<https://www.nonlinearcircuits.com/modules/p/dual-ota-vco>

ITS KILLING LM13700

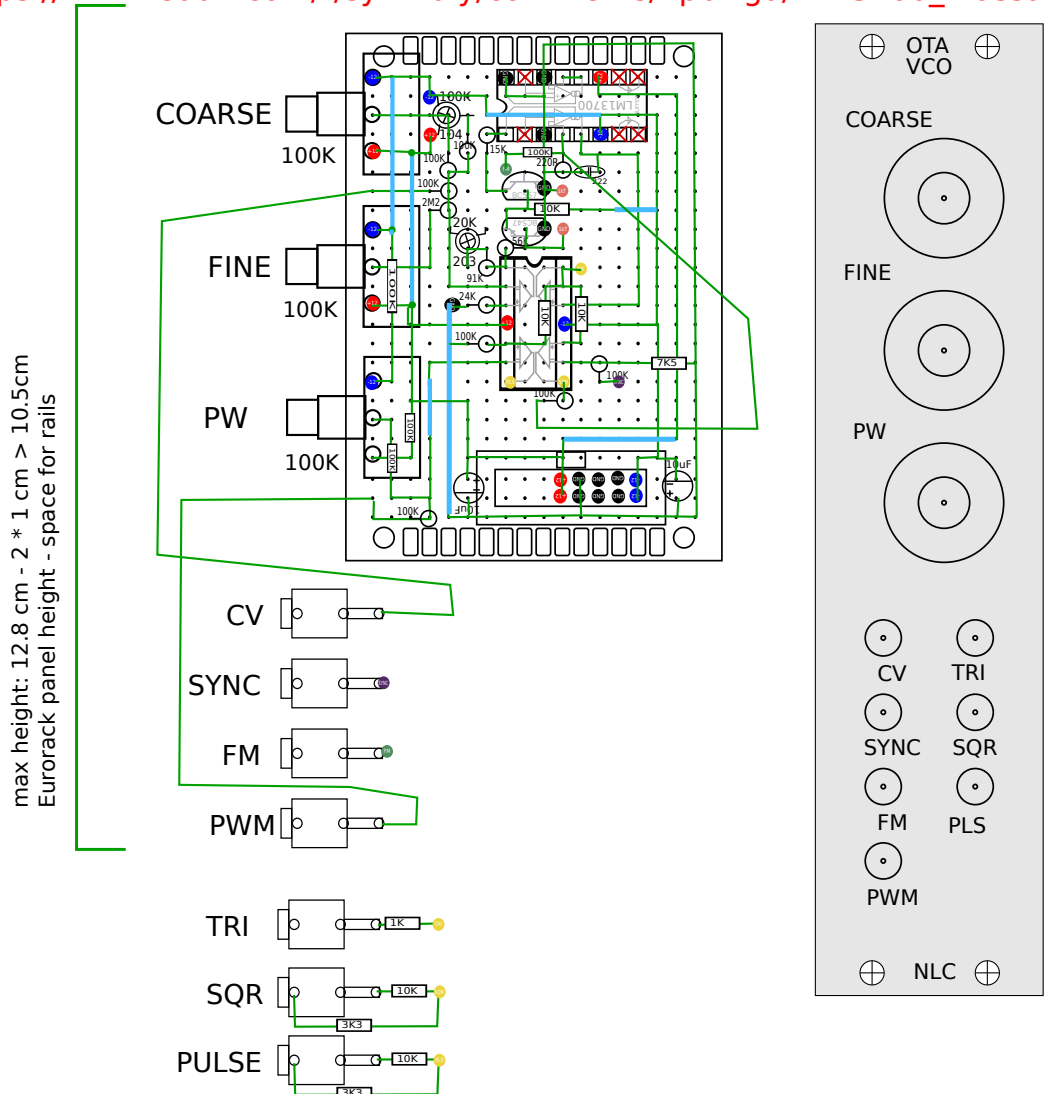
See: https://www.reddit.com/r/synthdiy/comments/npbwgd/lm13700_massacre/

A simplified version of this circuit was also used in the Null-A2. There it omitted the FM and Sync input, as well as the Square output.

try tying the diode bias to +12V over 12R
